STAFF RECOMMENDATION
712 Fatherland Street
October 16, 2013

Application: New Construction - addition
District: Edgefield Historic Preservation Zoning Overlay
Council District: 06
Map and Parcel Number: 08216024500
Applicant: Michael Kennedy, Owner
Project Lead: Sean Alexander, sean.alexander@nashville.gov

ELEVATIONS

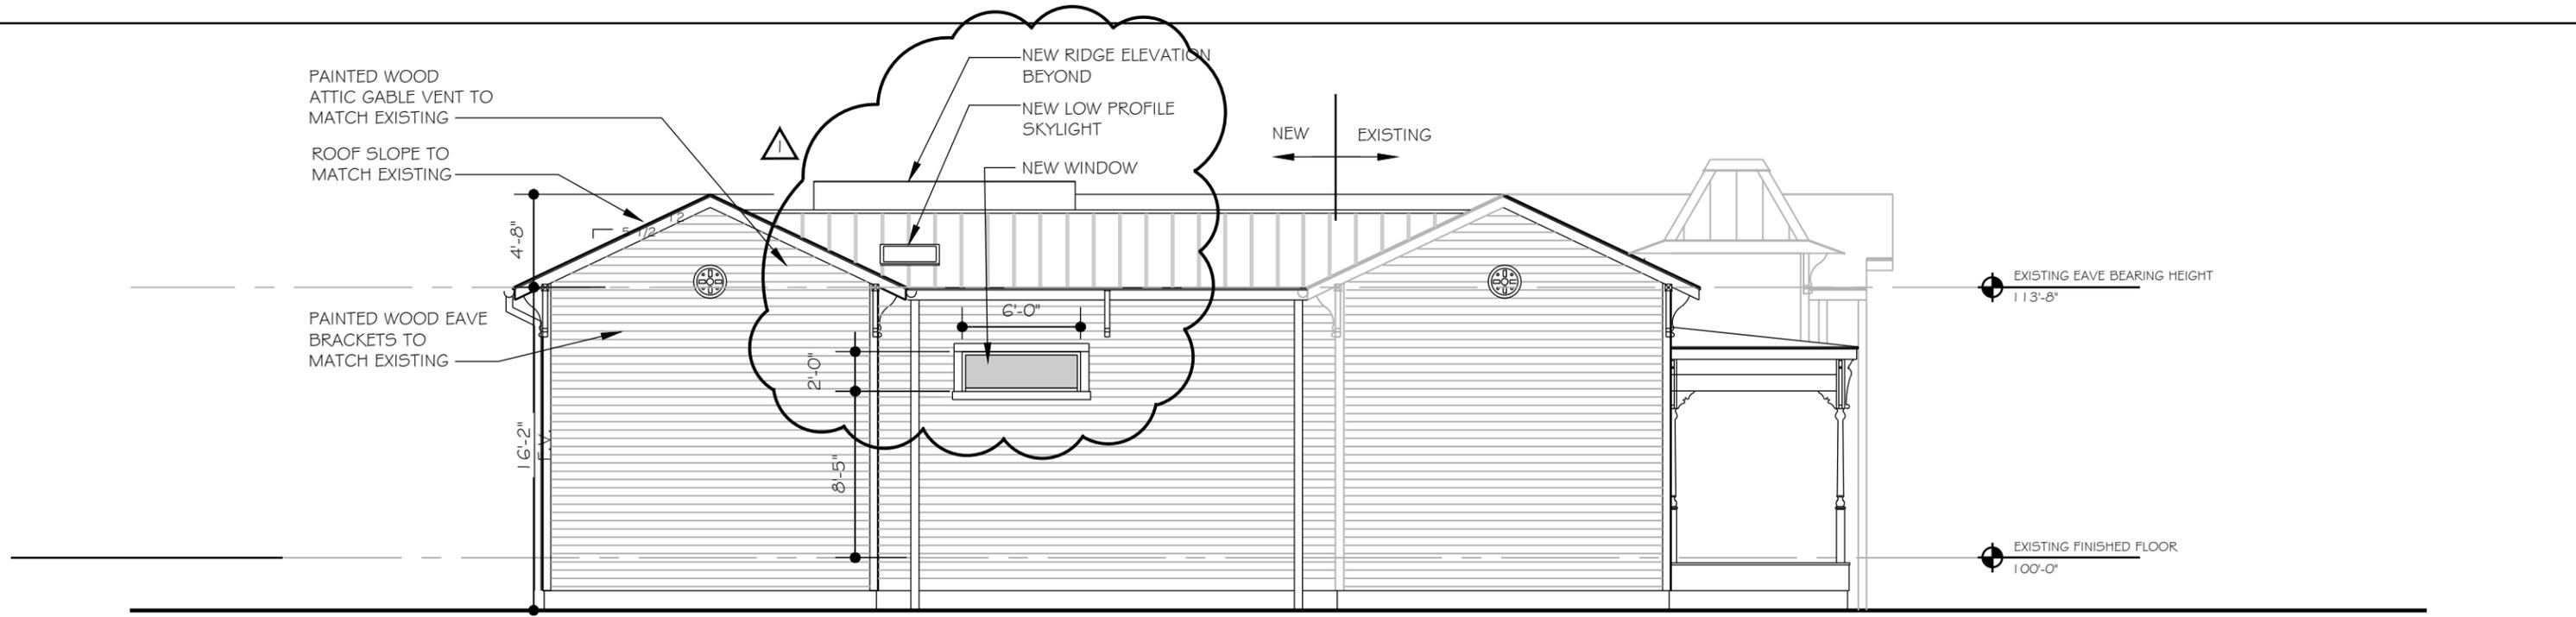
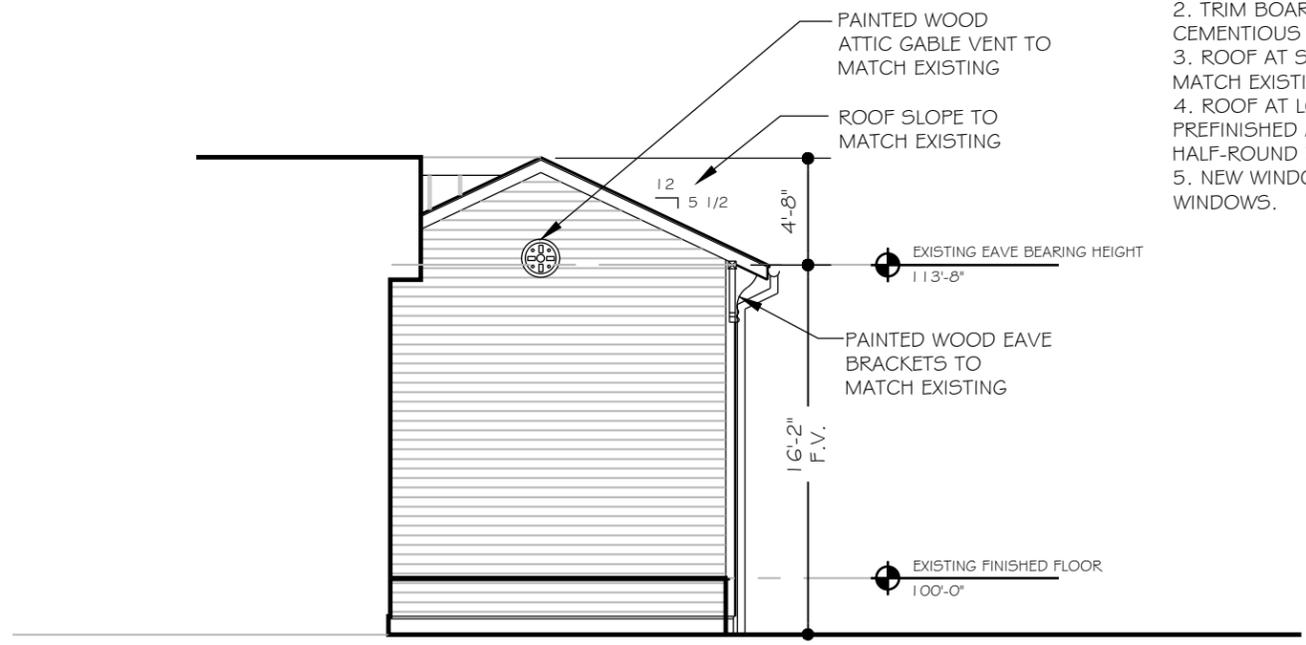
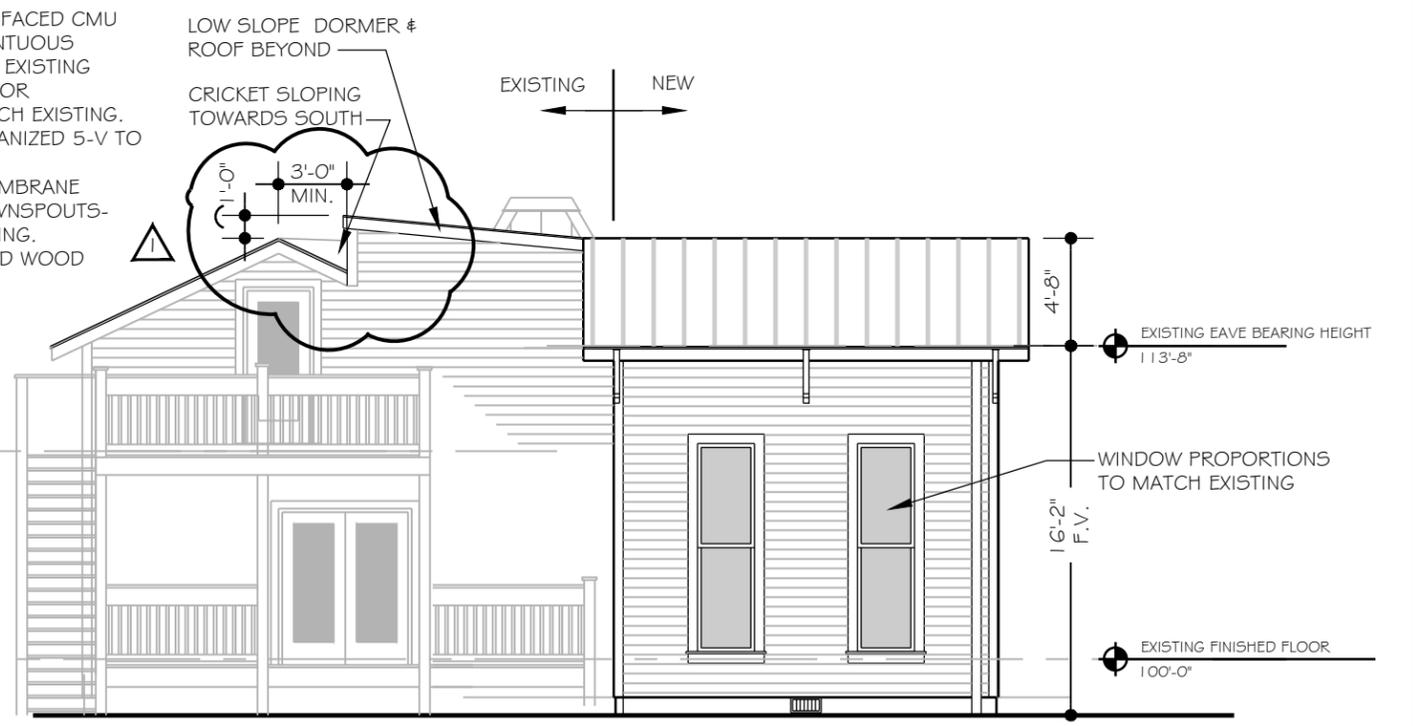
The exterior finishes of the addition include: split-faced concrete block foundation, cement-fiber siding matching the exposure of the original siding, and a 5-V crimped metal roof. The windows in the addition will be aluminum-clad wood. These materials are appropriate for new construction and meet guideline III.B.2.g.

Appurtenances & Utilities: No changes to the site's appurtenances were indicated on the drawings. The location of the HVAC and other utilities was also not noted. Staff asks that if they are not remaining in their present location, that the HVAC be located on the rear façade, or on a side façade beyond the midpoint of the house.

ROOF PLAN

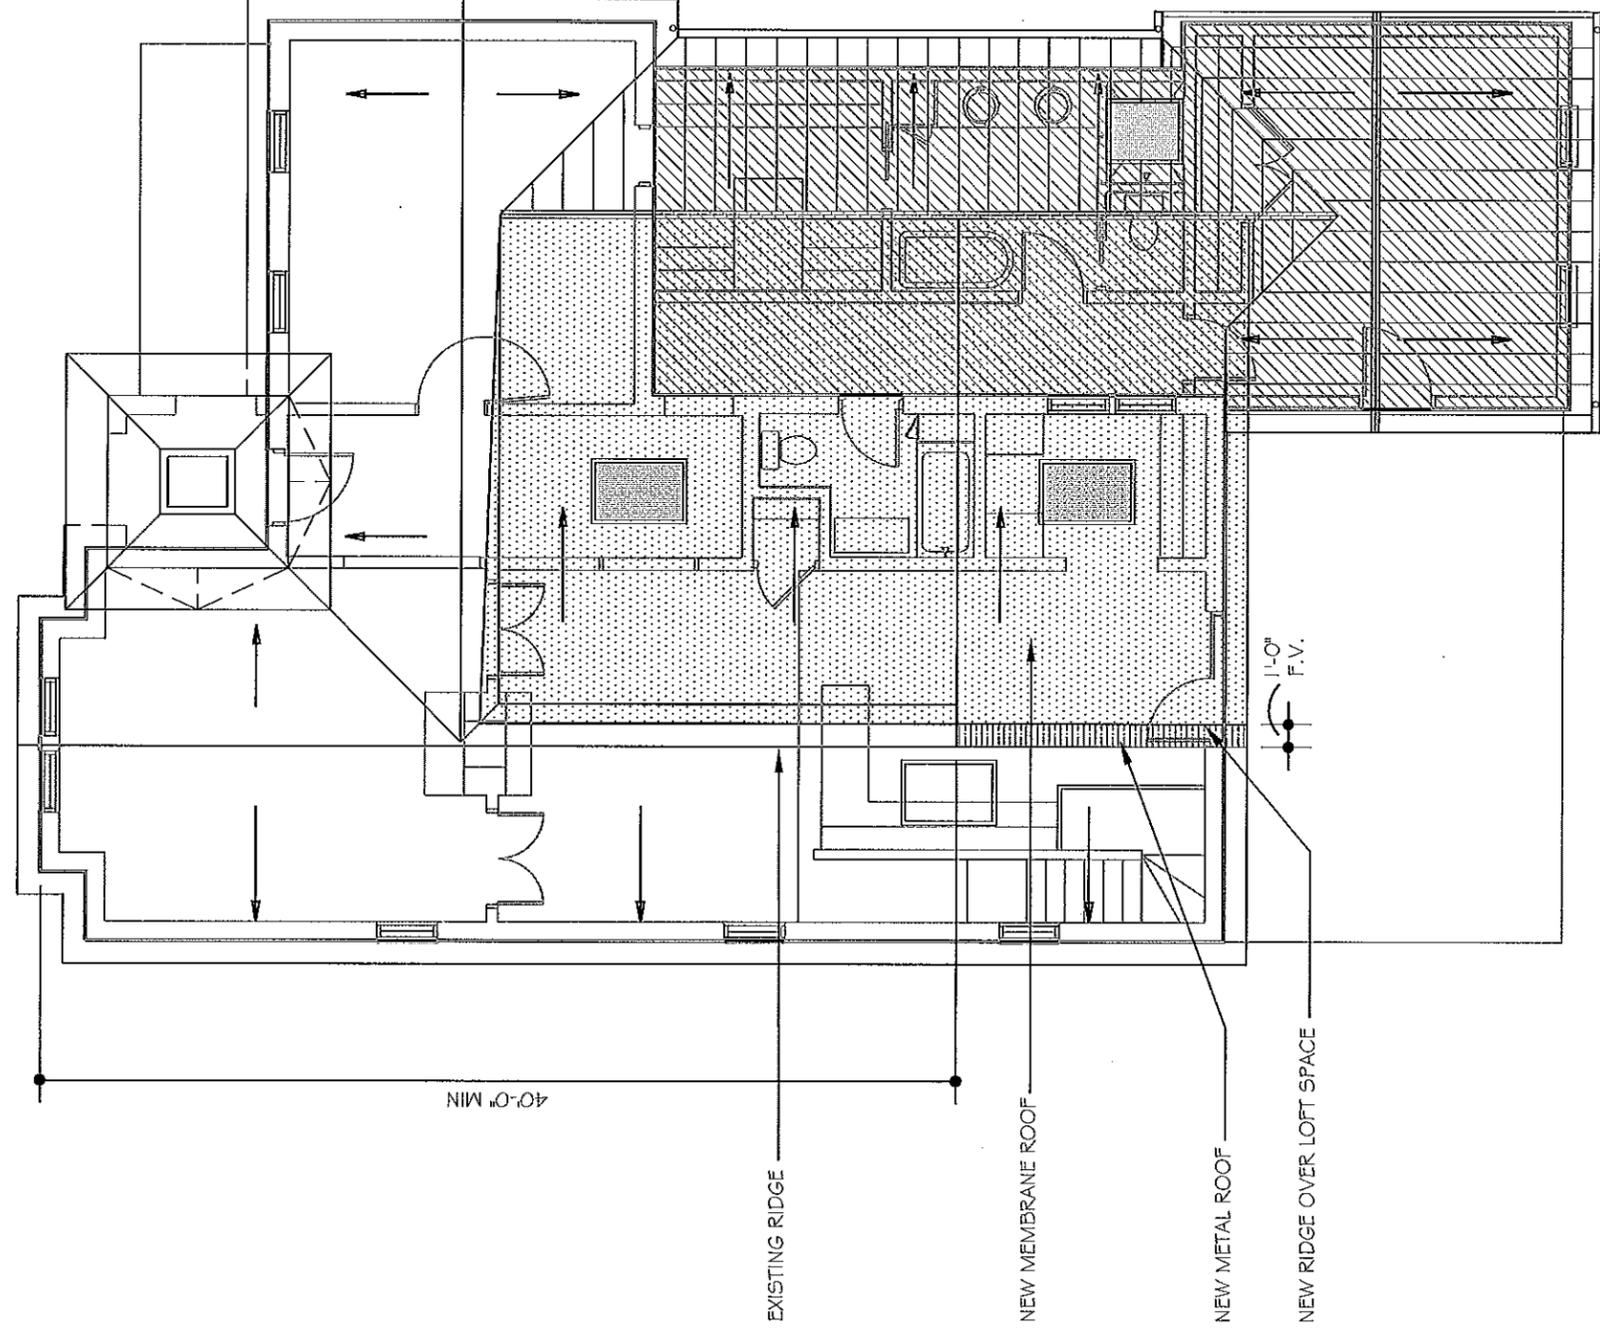
The proposed modification is for a portion of the rear addition between the original front-to-back ridge and the new front-to-back ridge to be one foot (1') taller than the original roof. The taller roof will be approximately forty feet (40') behind the front of the house

and three feet (3') in from the original side roof ridge, sloping down to tie in with the new front-to-back ridge of the addition. This modification will not disturb any portion of the ridge or visible side of the historic structure, and will not alter the appearance of the house from the right-of-way. Staff finds that this meets guideline III.B.1.a.

Staff recommends approval of increased height of the previously approved addition, finding it to meet the design guidelines for additions in the Edgefield Historic Preservation Zoning Overlay.
